# Tomingley Gold Project

# Response to Submissions

Major Project Application  
No. PA 09\_0155

March 2012

**Figure 4.20**  
**GEOLOGICAL CROSS SECTION IDENTIFYING AQUIFERS**

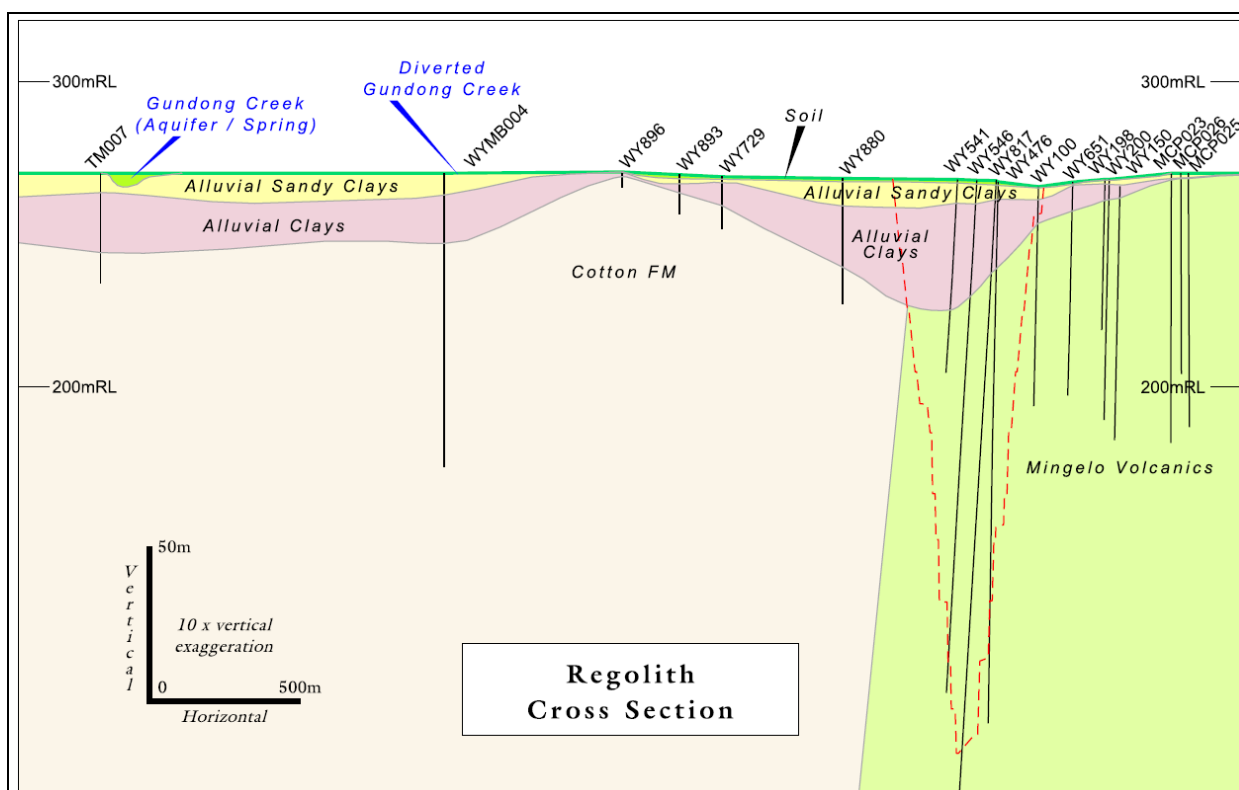
*Impax (2011) concludes that the Project is unlikely to have any adverse impact on the groundwater contained within the shallow alluvium of Gundong Creek for the following reasons.*

Figure 4.20 of the Environmental Assessment (reproduced below) illustrates in cross-section the positioning of the Cotton Formation bedrock between the Mine Site palaeochannel alluvium and Gundong Creek alluvium within which the Council bores draw water.

Figure 3.SW1  
MINE SITE SUB-CATCHMENTS

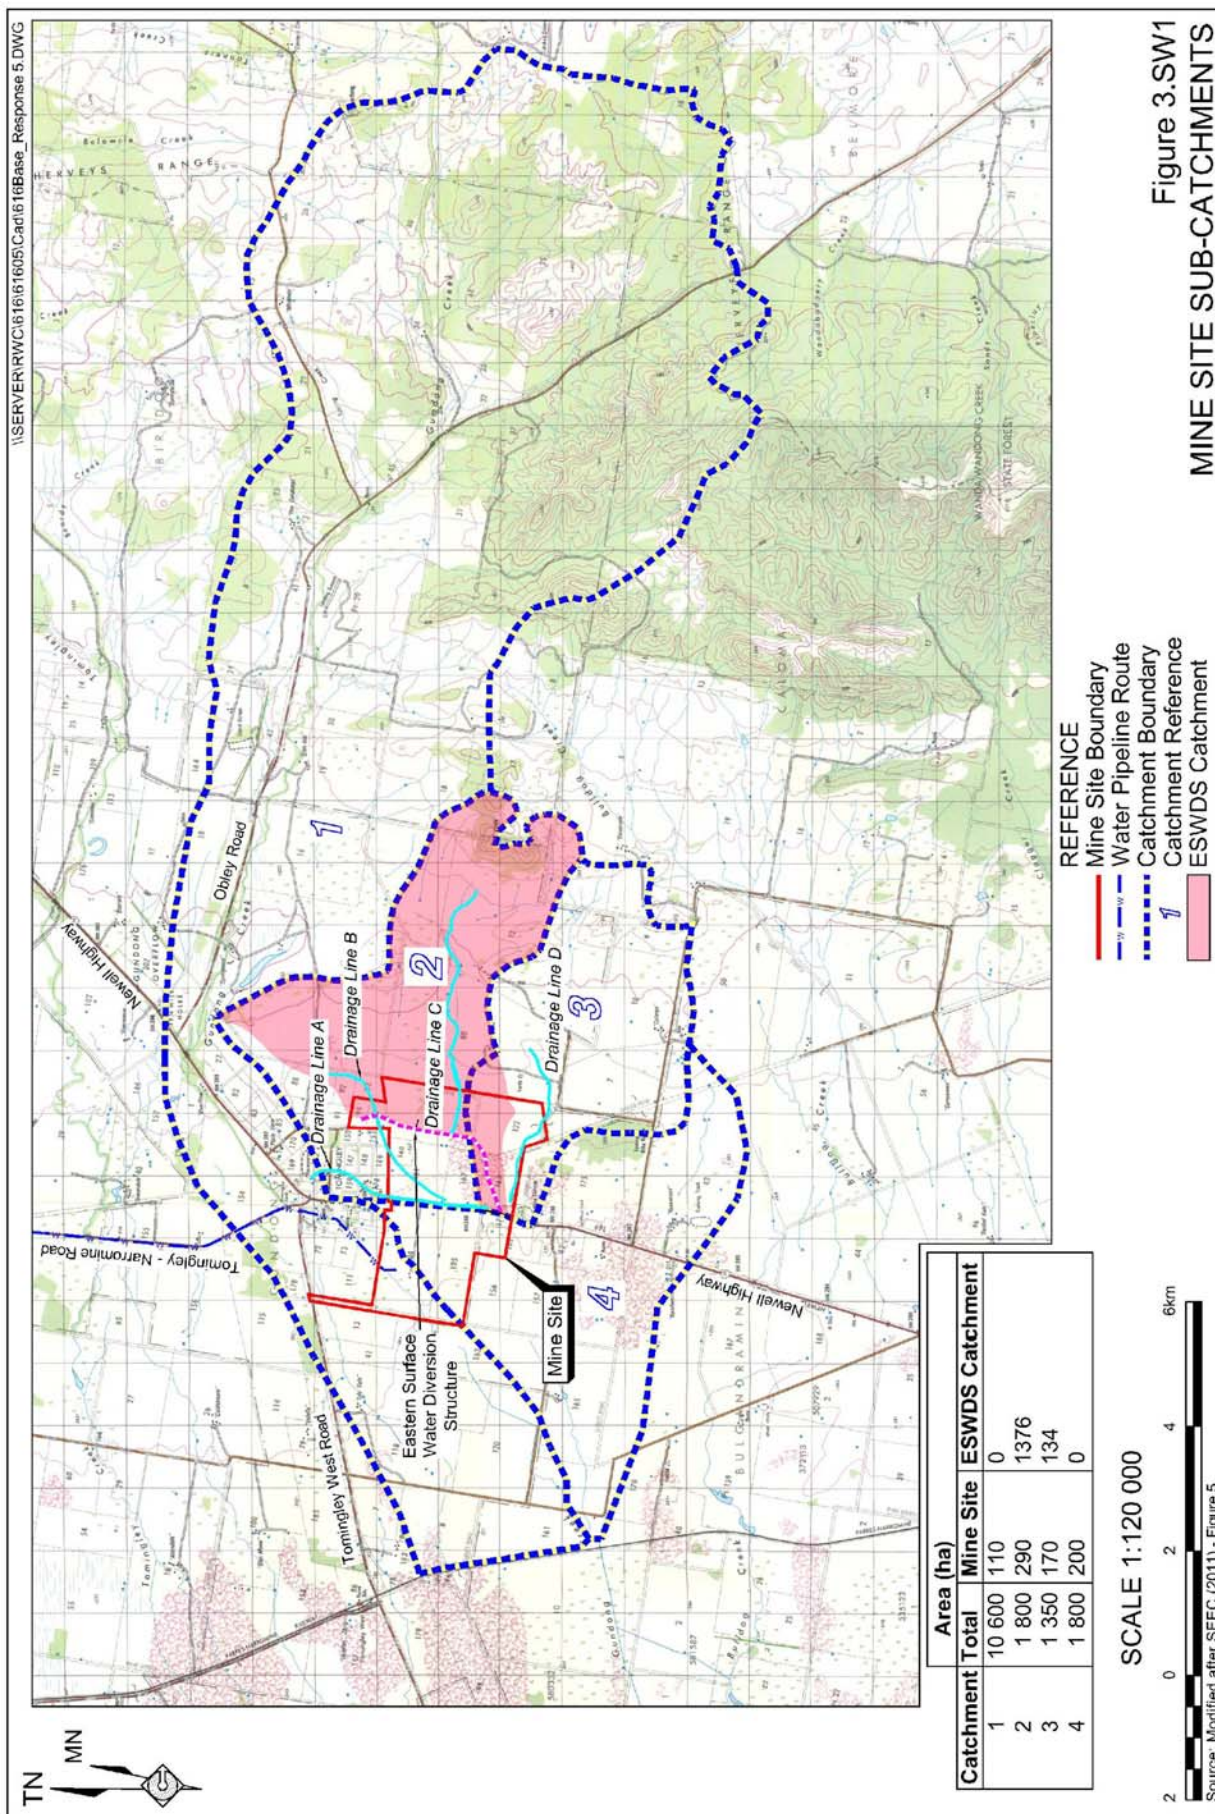
*“Figure 2.1 shows the Eastern Surface Water Diversion Structure appearing to catch and transfer water from a large catchment area to a discharge point adjacent to the Newell Highway. Council seeks advice as to the discharge arrangements for this water and its possible impact on the Newell Highway (eg culvert capacity, flow paths, etc).”*

The Eastern Surface Water Diversion Structure (ESWDS) is located within Mine Site Catchments 2 and 3, and would convey surface flows from approximately 75% of Catchment 2 and 10% of Catchment 3 (affecting Drainage Lines B, C and D) (see **Figure 3.SW1**). The diverted flow would be discharged to the east of Newell Highway between the two existing culverts (nominated as Culverts 1 and 2 on Figure 7 of the Surface Water Assessment).

Notably, this provides a similar (but slightly reduced volume of water to these culverts as currently occurs, i.e. all flows from Catchments 2 and 3 travel in a roughly westward direction across the Mine Site until they reach the Newell Highway, where the highway itself acts to divert flows to the south and into the aforementioned culverts. As a result, the proposed eastern surface water diversion would not increase the catchment size or volume of water reporting to these culverts. In fact, by virtue of the water capturing structures such as the Caloma open cuts and sediment basins, the volume of water reporting to the Newell Highway culverts would be reduced.

Anecdotal evidence noted in Surface Water Assessment prepared by SEEC, which Council would be aware of, notes that these culverts are periodically overtopped, with short-term (less than 3 hours) flooding over the highway. It is likely that during high rainfall and runoff periods, a similar level of flooding would be experienced. Therefore, given the lack of change to the local catchments reporting to these culverts, it is highly unlikely that the proposed water management measures proposed for the Tomingley Gold Project would alter the existing hydrological regime at this point.

**Figure 9.1** Freeboard (taken from Figure 1 the WA DMP Residue (Tailings) Manual 1999)

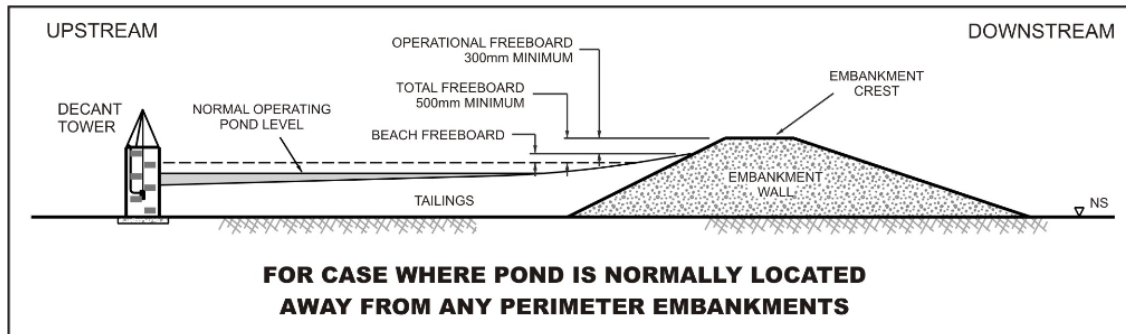
*“There are two documents which have been referred to in determining the freeboard requirements. The NSW Dams Safety Committee, in publication DSC19, has provided freeboard requirements. The Western Australian DMP publication “Guidelines on the Safe Design and Operating Standards for Tailings (Residue) Storage” dated May 1999, also defines the way in which the freeboard, upstream of the embankments, should be measured. Freeboard (**Figure 9.1**) comprises three (3) elements:*

The Stage 1 embankments forming the storage have been designed to be constructed to ensure that all freeboard conditions are met. The Operating Manual, which will be issued prior to the storage being commissioned, will clearly state the timing required to construct successive lift of the embankments to maintain those freeboard conditions. “
